Responses to NRC Letter Dated July 17, 1998

Request for Additional Information on the Reclamation Plan for the White Mesa
Uranium Mill

Source Material License SUA-1358

Re: White Mesa Uranium Mill
Response to NRC's Questions Dated July 17, 1998
Site Reclamation Plan

ATTACHMENT 4-E

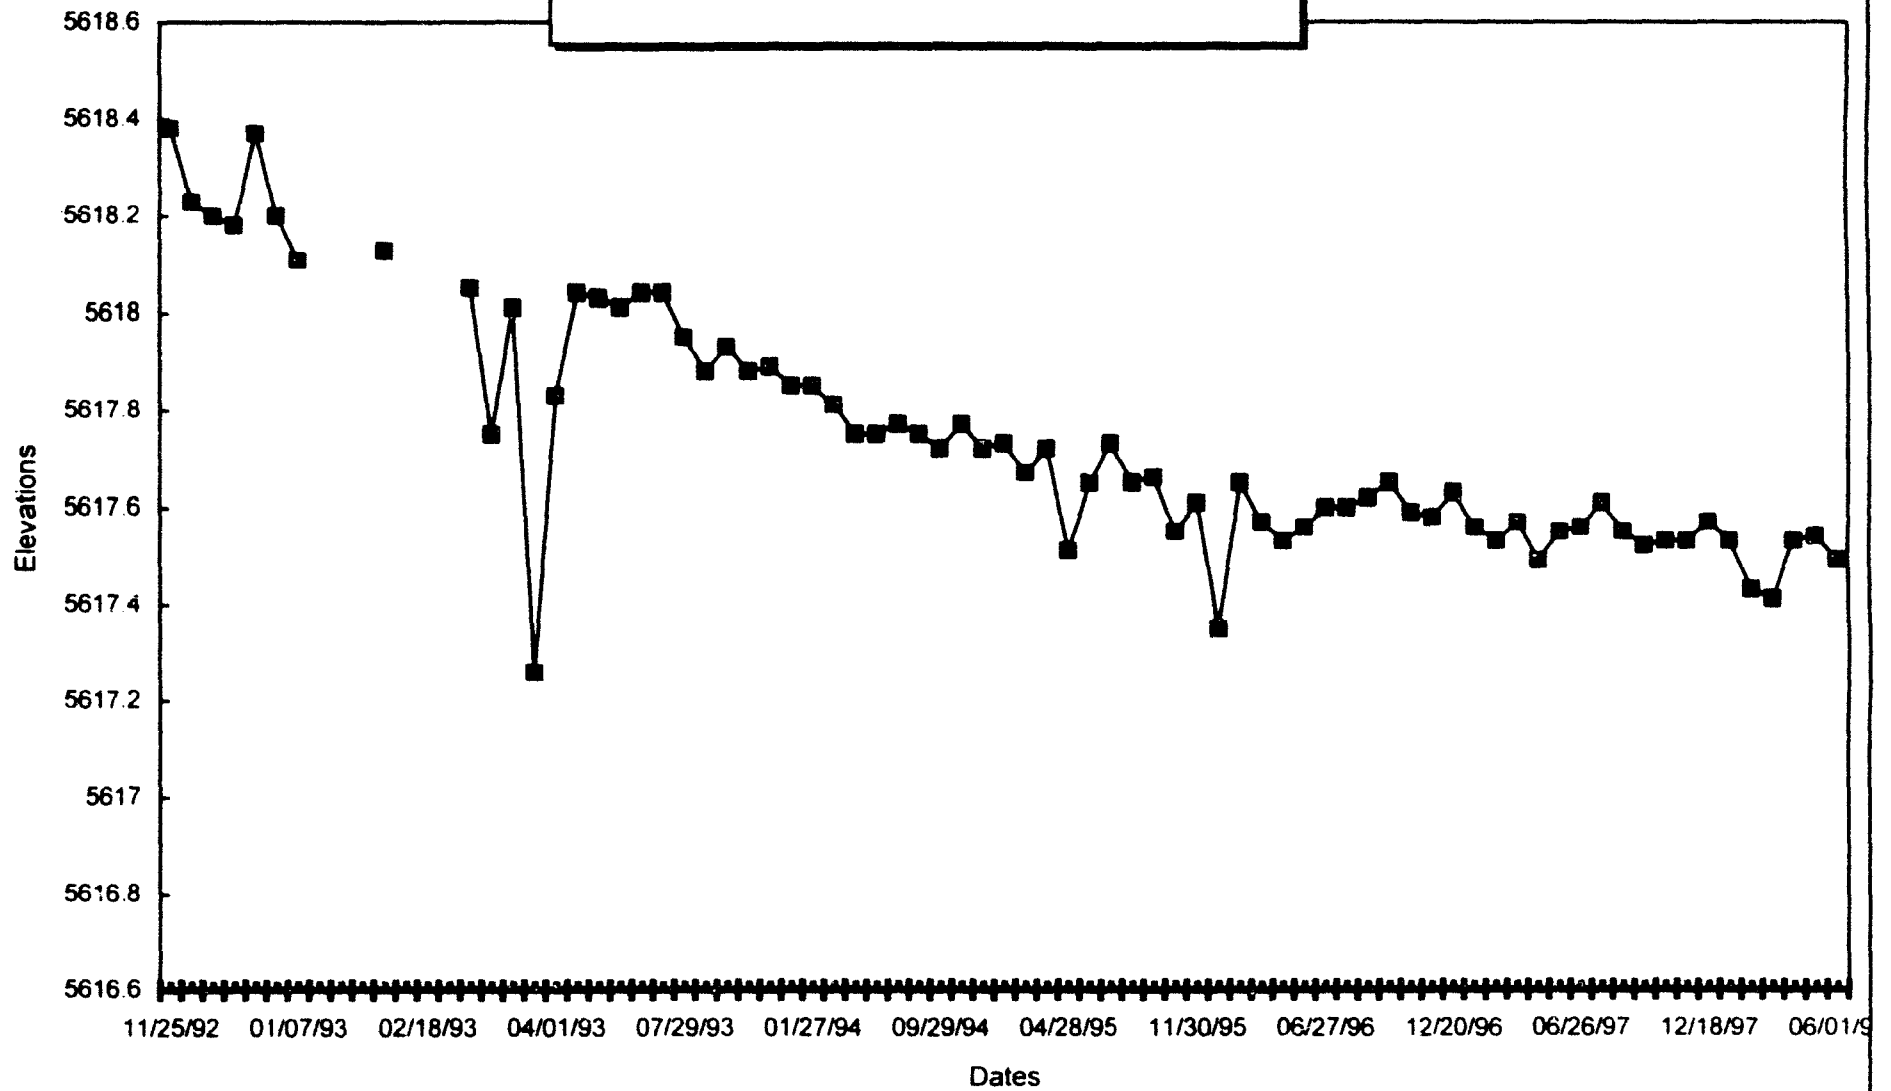
9. *Additional information and analysis are necessary in the calculation of the spatial variation of settlement and any potential for cover cracking due to this differential settlement. This calculation requires estimation of the settlement at various locations to provide an adequate areal coverage. Moreover, due to the heterogeneity of the tailings materials, a settlement analysis that takes into account the spatial variability of the material properties is indispensable to developing an adequate settlement monitoring program.*

As an alternative, HUSA proposes that settlement evaluation based on settlement monitoring is more appropriate for the White Mesa tailings than exploration and testing followed by calculations. Settlement data collected to date are shown in Attachment 4. Additional settlement monuments will be installed on a regular grid, illustrated in Figure 1 of Attachment 4, and measured on a schedule that will provide data to evaluate settlement rates and patterns. From these data, estimates can be made of the amount of settlement to be expected and the time until 90% of primary settlement is achieved.

DEPTH VS DURATION FOR 6-HR PMP
WHITE MESA MILL, UTAH
ATTACHMENT 8 RESPONSE TO NRC COMMENTS 7/17/98

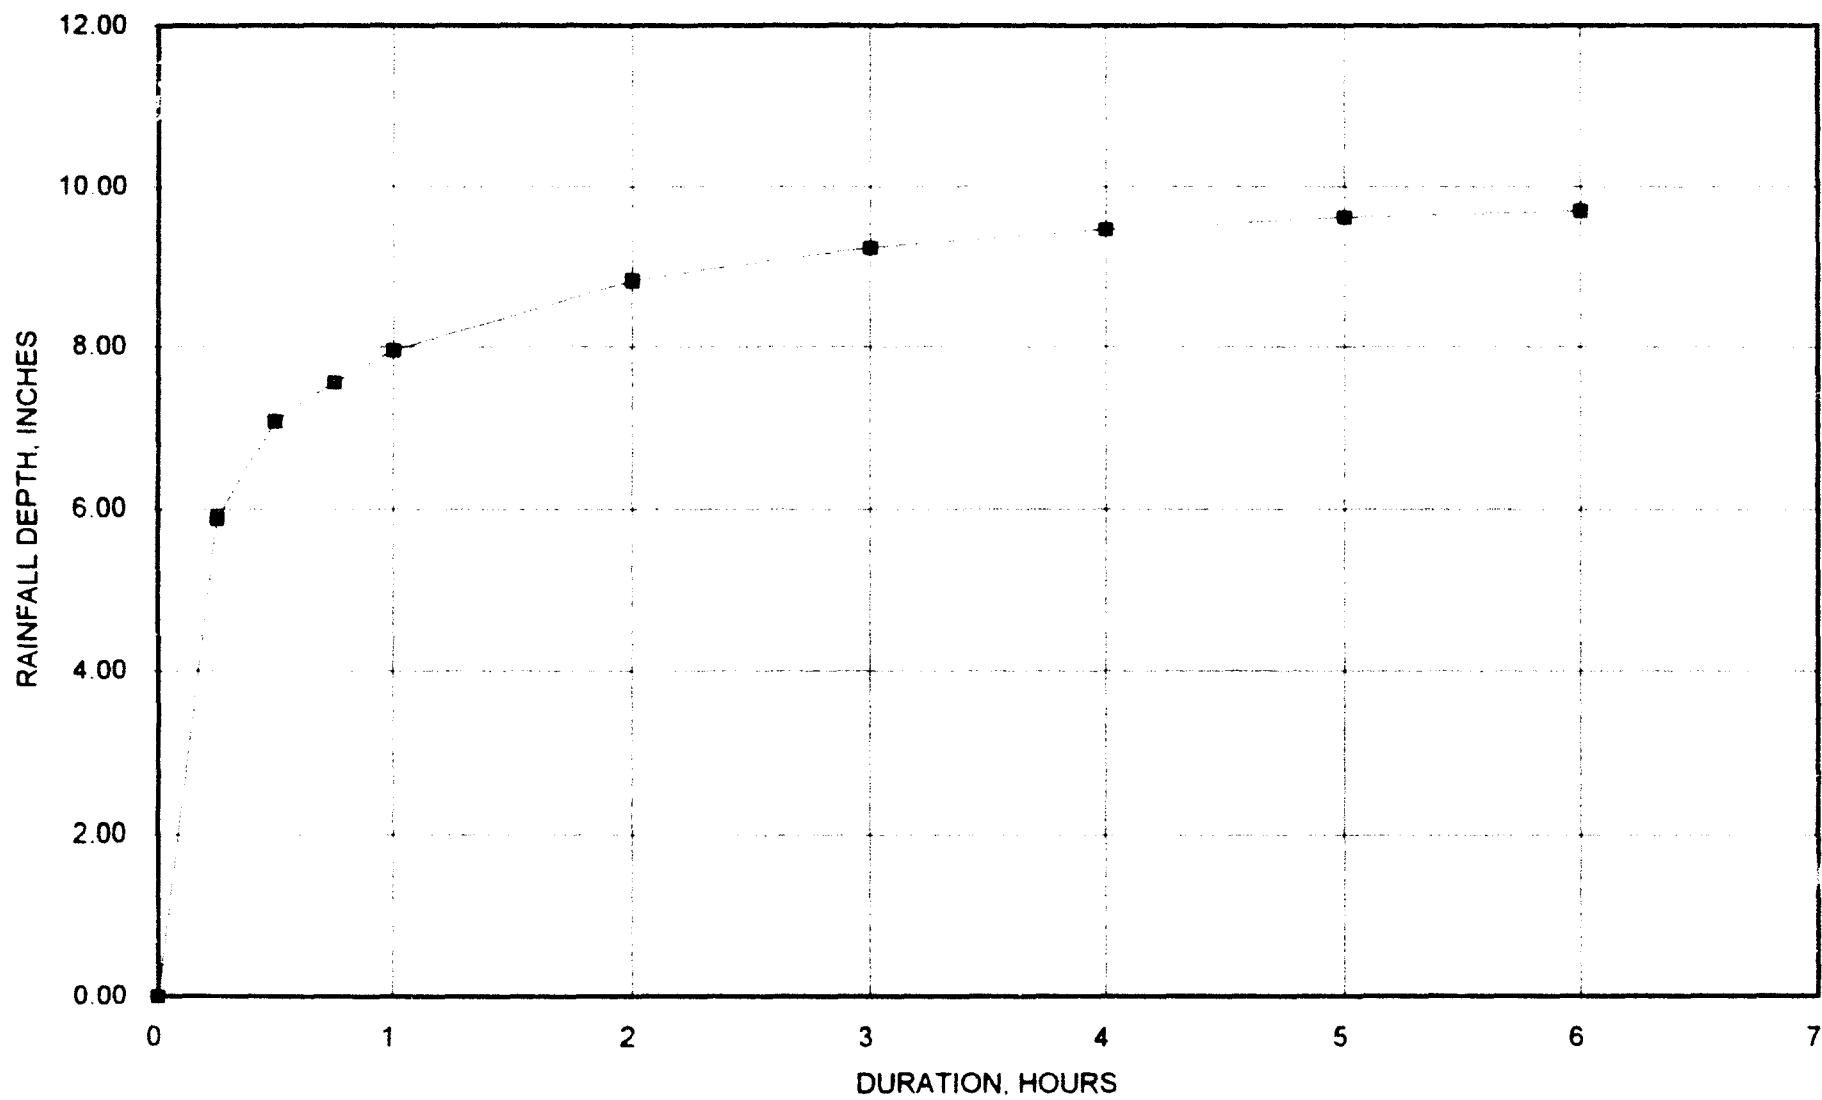
To evaluate the adequacy of the discharge channel, it is necessary to know the drainage area contributing flow to the channel and the bases for IUSA's estimates of peak PMF flow rates, channel velocities, flood routings, etc. Such information, including detailed drawings and calculations, are needed to determine if the channel and its associated erosion protection are adequate. Therefore, IUSA should provide this information or, if such information has been provided to NRC in the past, IUSA should provide appropriate references.

The PMF peak discharge through the Cell #1 discharge channel was calculated in the same way as described above for comment #16. The drainage area, 143 acres, was measured from the most recent 1"=200' scale topo map of the site. The longest flow path is 4800 feet. The peak PMF discharge

ROCK APRON AT TOE OF CELL OUTSLOPE

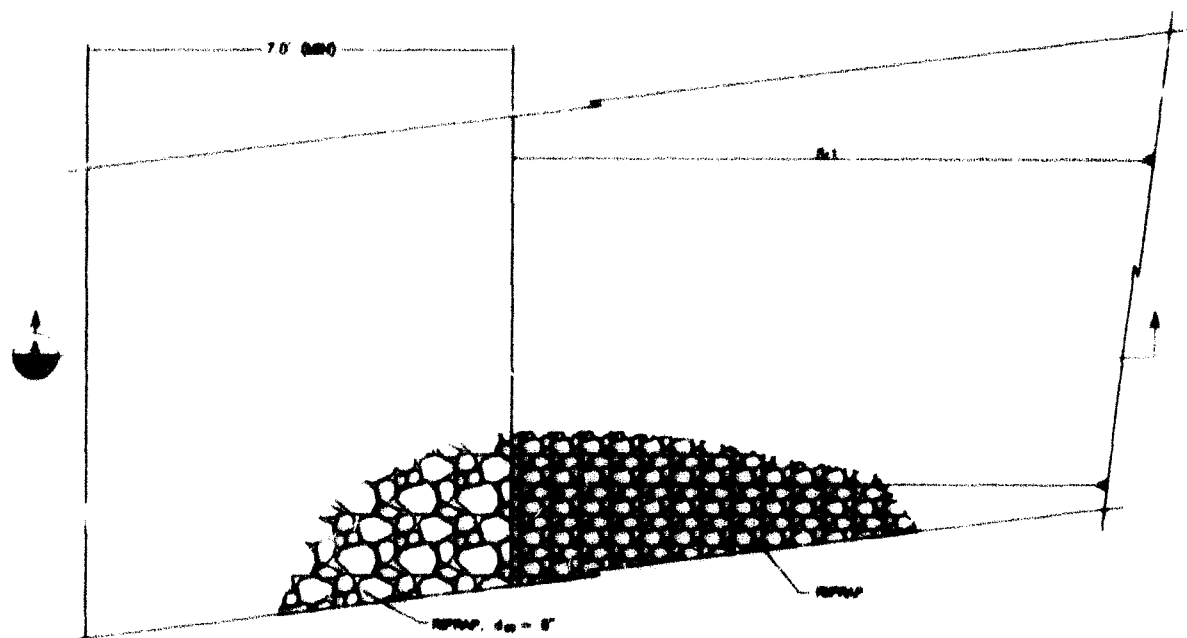
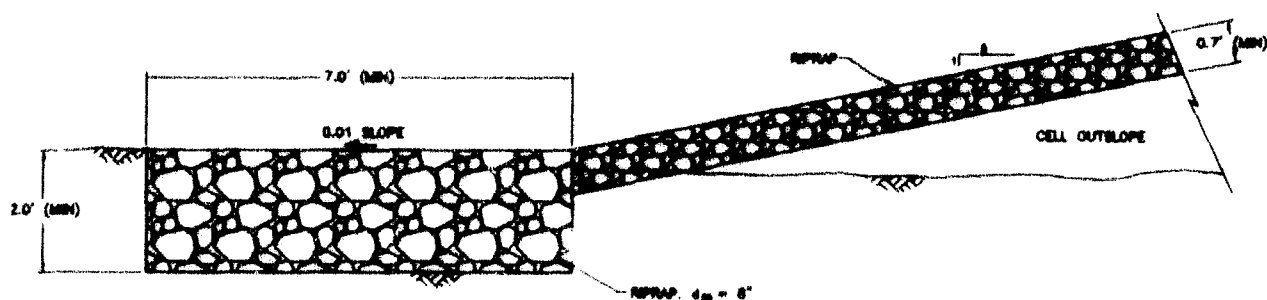
Detailed drawings and calculations should be provided to document the design bases and to show the design configurations of the rock toes, particularly in those locations where the toes transition into areas where sandstone bedrock is present. The competency of the bedrock layer also should be assessed.

Attached is a drawing (Figure 4 – Attachment 12) showing a plan view and cross section of a typical rock apron at the toe of cell #3 outslope. The apron is at least 7.0 feet wide and 2.0 feet thick with a surface slope of 0.01 ft/ft, and the d_{50} of the rock in the apron is 8.0 inches. The depth of scour in the sand soil predicted under PMP is 1.3 feet, so the apron thickness is greater than the scour depth.

If bedrock is encountered at less than this depth, the key will be taken only to the top of rock. The calculations of rock sizes needed to resist erosion and the scour depth at the edge of the rock apron are included in table form with this response (Attachment 12).
